PLANNING REPORT #33-88

PLANNING DEPARTMENT REPORT

OFFICE/GARAGE FACILITY

RYDER TRUCK RENTAL, INC., APPLICANT

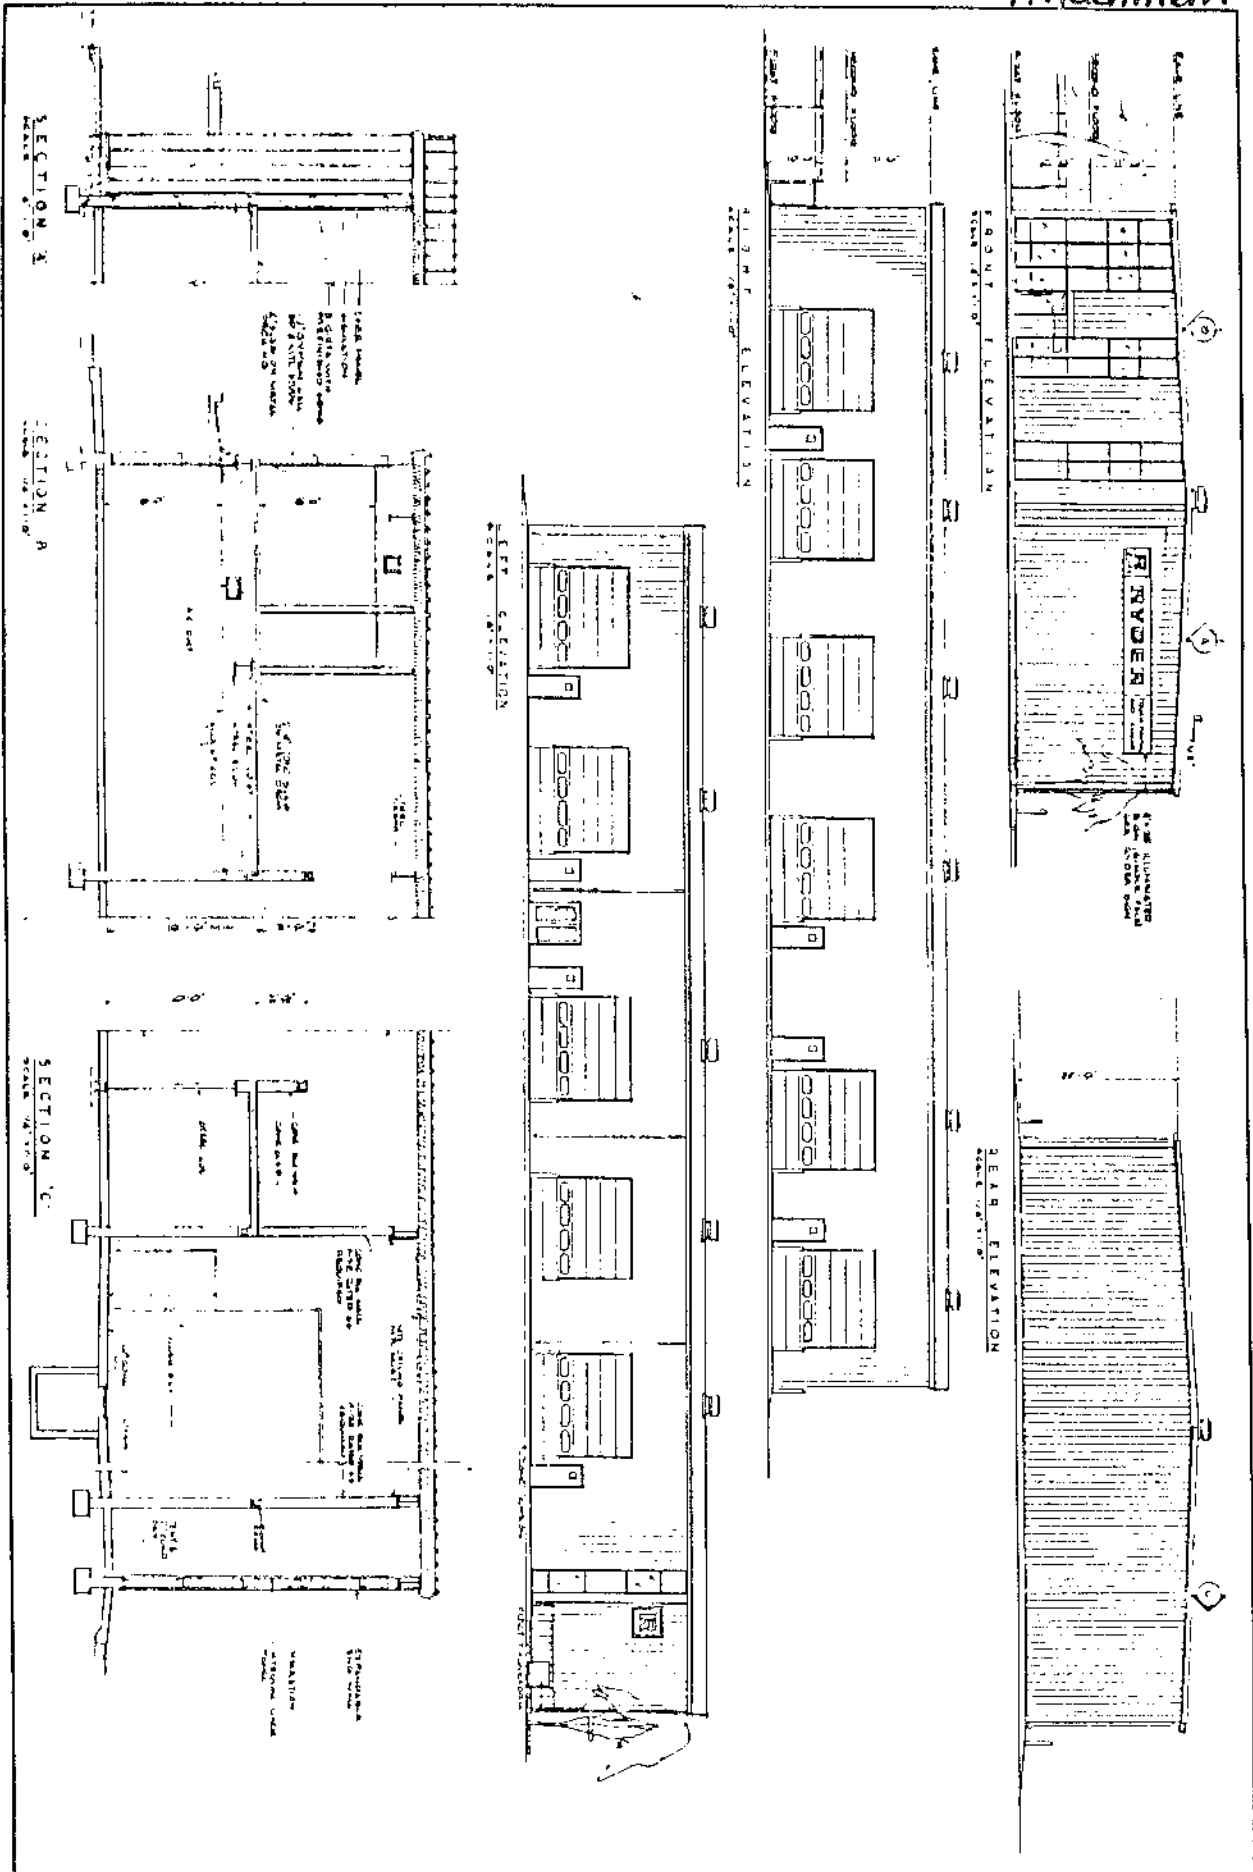
This memo is in reference to the Ryder Truck landscape plan, located in the Pine Tree Industrial Parkway.

1. The screen located on the rear N.E. property line should extend from 40' of the S.E. property line of the City of Portland easement to the 50' N.W. jog at rear of the property line.

PROJECT
**Landscape Plan
Proposed Facility
PORTLAND, MAINE**

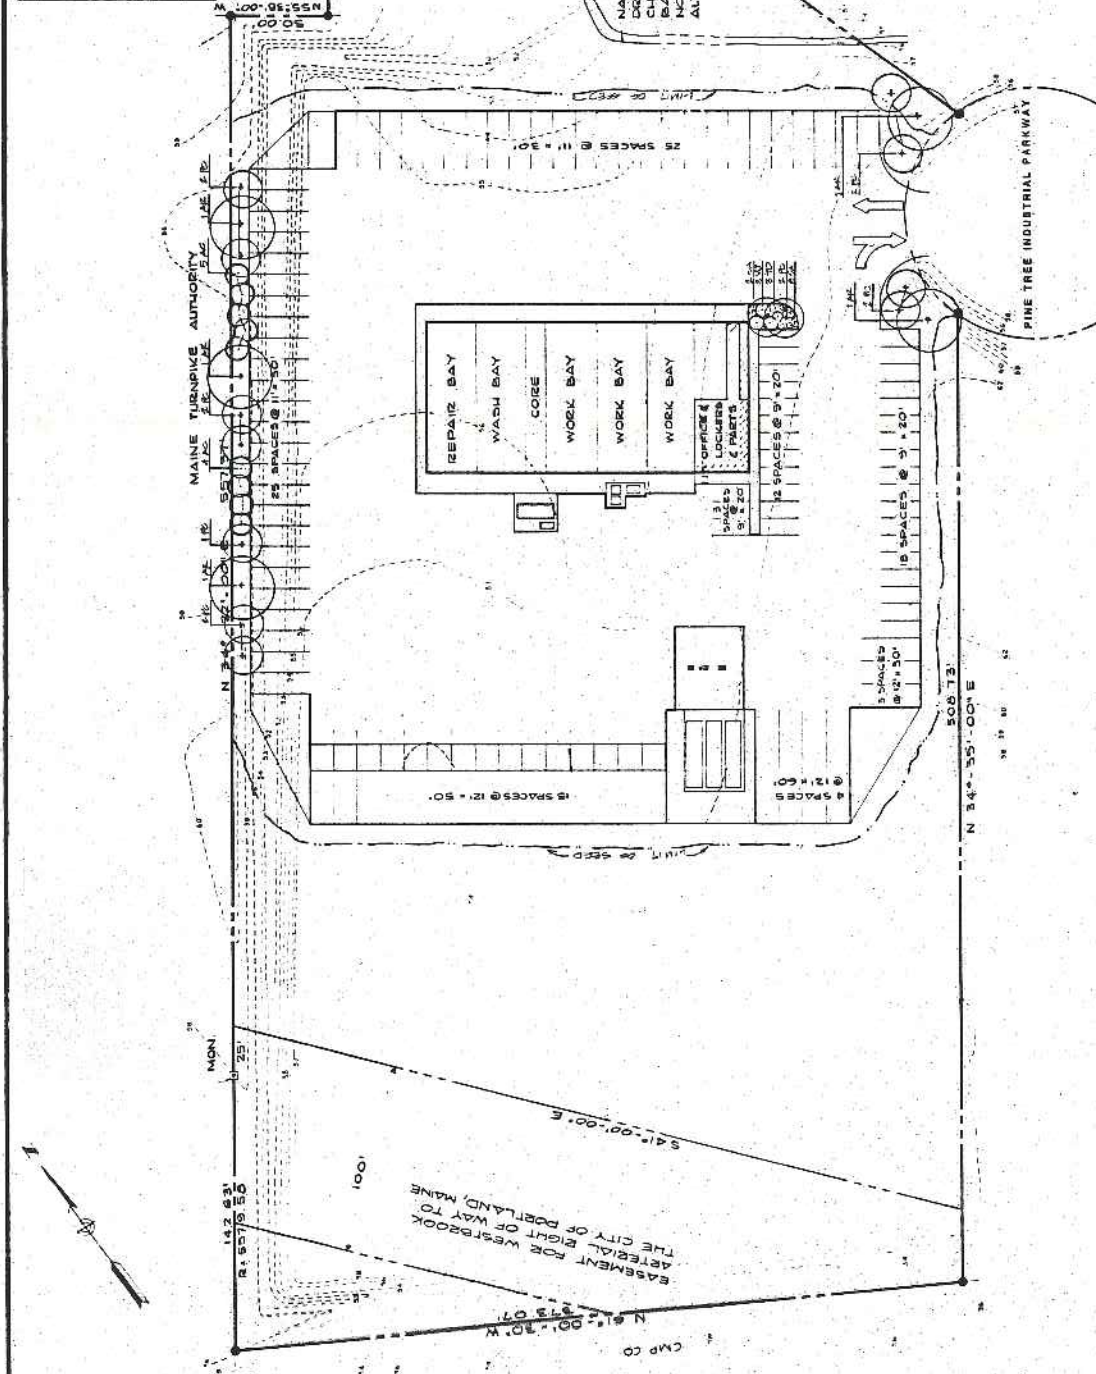
This memo is in reference to the Ryder Truck landscape plan, located in the Pine Tree Industrial Parkway.

1. The screen located on the rear N.E. property line should extend from 40' of the S.E. property line of the City of Portland easement to the 50' N.W. jog at rear of the property line.
